Germantown Worksession #4

MCPB October 20, 2008 — Item #3

SUBJECT: Mandatory Referral

Montgomery College - Germantown Business Park

KAY PROPERTY

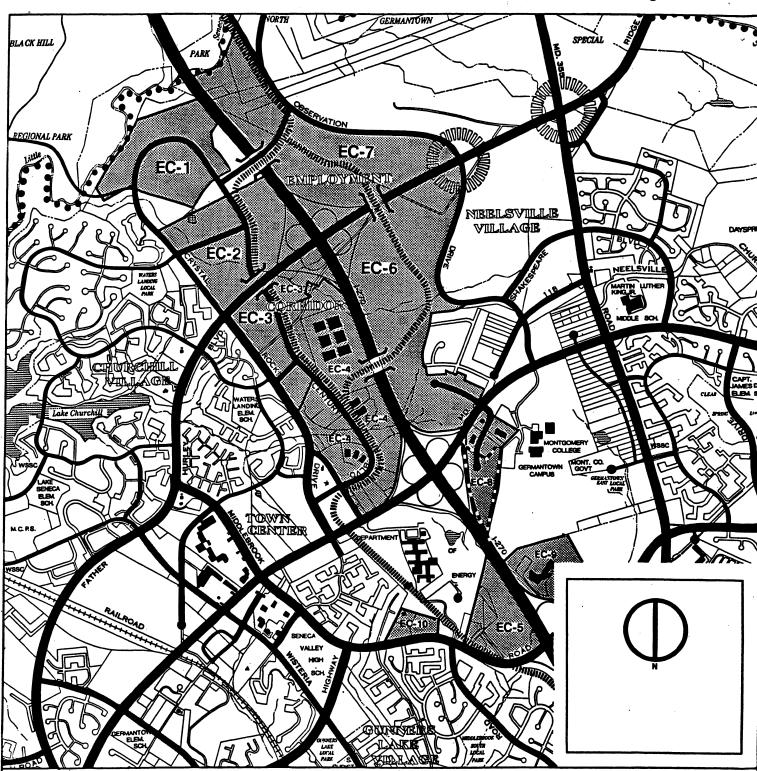
The Montgomery College Board of Trustees proposes to purchase a 20-acre parcel adjacent to the Montgomery College Germantown campus for use as a business park (Figure 1). This property acquisition enhances long-range plans of the College and the Montgomery County Department of Economic Development to promote the biotechnology industry and the College role in supporting this industry.

Employment Corridor: Analysis Areas

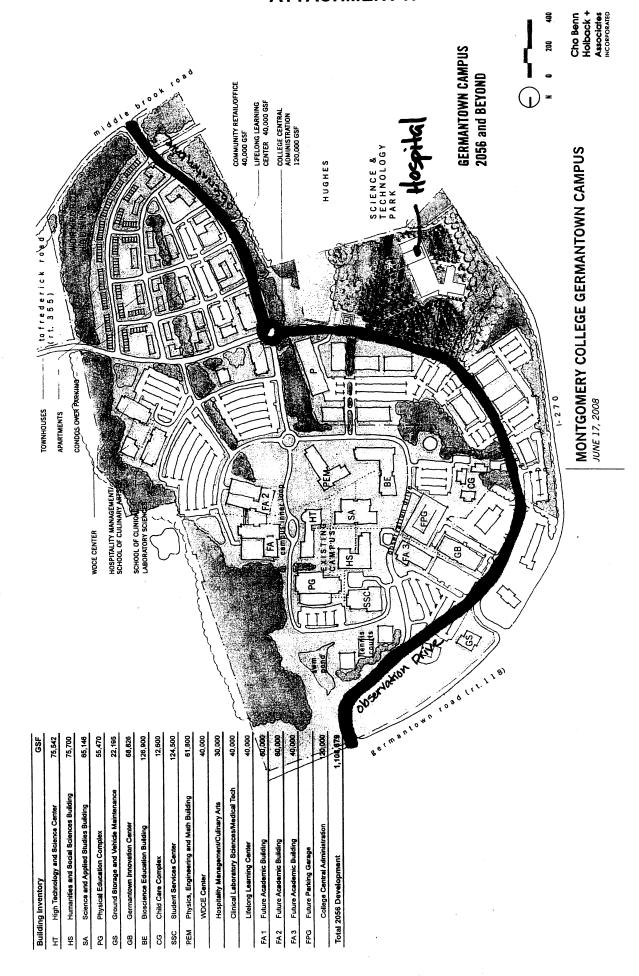
Master Plan – The proposed property is covered by Analysis Area EC-8 in the Employment Corridor of the Germantown Master Plan, adopted and approved in 1989 (Figure 2). The Master Plan states:

The Master Plan establishes a guideline for the amount of development for the remaining parcels of EC-8, including the Kay property. This amount may be slightly less than contemplated for the Montgomery College business park and should form the basis for the Germantown Campus Facility Master Plan now underway. Additional comments in the Transportation section of this report address circumstances where the .5 FAR may be exceeded.
